SERVICE INFORMATION NO. SI 42-063/1

EASA EAD No. 2008-0027-E and
Thielert Service Bulletin TM TAE 125-1005 P1 Bracket HP Line HPP-Fuel Rail, Rev. 1
ATA-Code: 73-00

<u>Technische Mitteilung Nr. / Datum:</u>	TM TAE 125-1005 P1, Rev. 1 / 11.02.2008
<u>Service Bulletin No. / Date:</u>	TM TAE 125-1005 P1, Rev. 1 / February 11, 2008
<u>Betrifft:</u>	Installation Halter Kraftstoffhochdruckleitung
<u>Subject:</u>	Installation of Bracket High-Pressure Fuel Line
<u>Betroffenes Luftfahrtgerät:</u>	TAE 125-02-99 (CENTURION 2.0)
<u>Type affected:</u>	TAE 125-02-99 (CENTURION 2.0)
<u>Betroffene Geräte-Nr.:</u>	Motorseriennummern 02-02-1500 bis 02-02-2279
<u>Models affected:</u>	Engine Serial Number 02-02-1500 to 02-02-2279
<u>Einstufung:</u>	Kategorie P1 – Sicherheit
<u>Classification:</u>	Category P1 – Safety
<u>Ausführung bis:</u>	Gesamtmotorlaufzeit unter 20 Std.: Maßnahmen sind vor Erreichen einer Gesamtmotorlaufzeit von 30 Std. oder mit der nächsten Inspektion durchzuführen, maßgebend ist das ersteintreffende Ereignis. Gesamtmotorlaufzeit über 20 Std.: Maßnahmen sind innerhalb der nächsten 10 Flugstunden oder mit der nächsten Inspektion durchzuführen, maßgebend ist das ersteintreffende Er

Bild 1 / Fig. 1

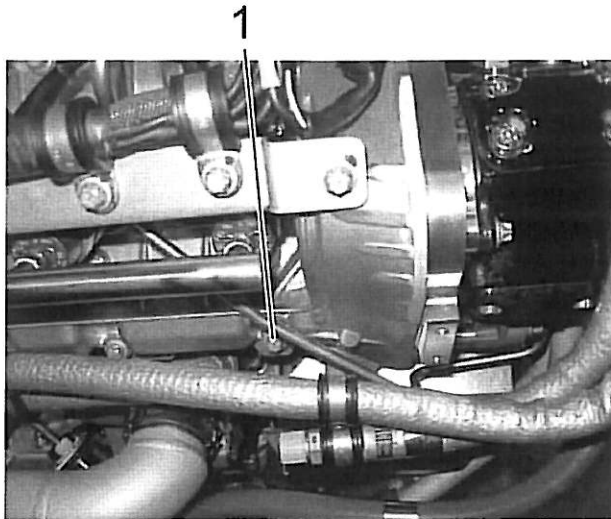
1. Detach the screw of the cylinder head cover. See Fig. 1.
2. Attach the spacer to the cylinder head cover. See Fig. 3.
Tightening torque:
12 Nm
3. Remove the high-pressure fuel line. See Fig. 2.

Bild 2 / Fig. 2

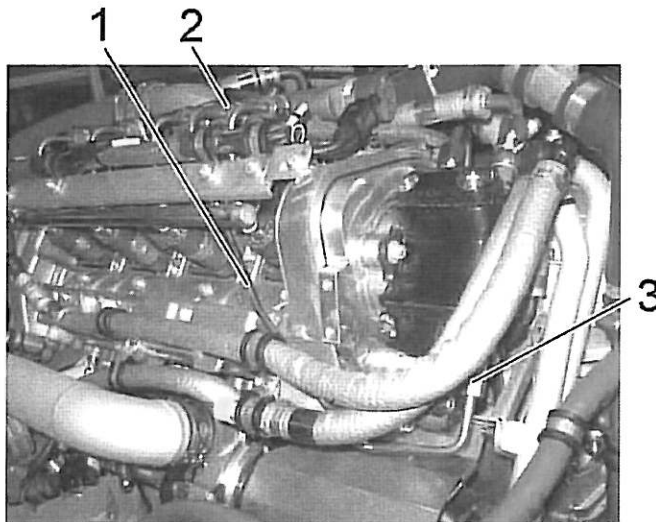
8. Tighten the screw of the fastener. See Fig. 3.
Tightening torque:
7 Nm
9. Tighten the union nuts of the high-pressure fuel line. See Fig. 2.
Tightening torque:
Union nut high-pressure pump (wrench size 14mm): 22 Nm
Union nut fuel rail (wrench size 18mm): 27 Nm
10. Carry out a ground run with data recording in accordance with the current Operation & Maintenance Manual OM-02-02.
11. Carry out a visual inspection and check for leaks.

Bild 3 / Fig. 3

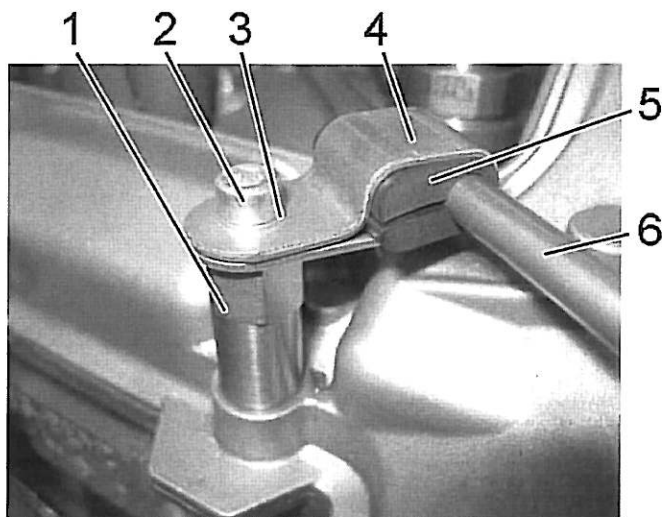
5. Attach the fastener and the insert to the high-pressure fuel line. See Fig 3.
6. Attach the fastener to the spacer using one bolt and one washer. See Fig. 3.
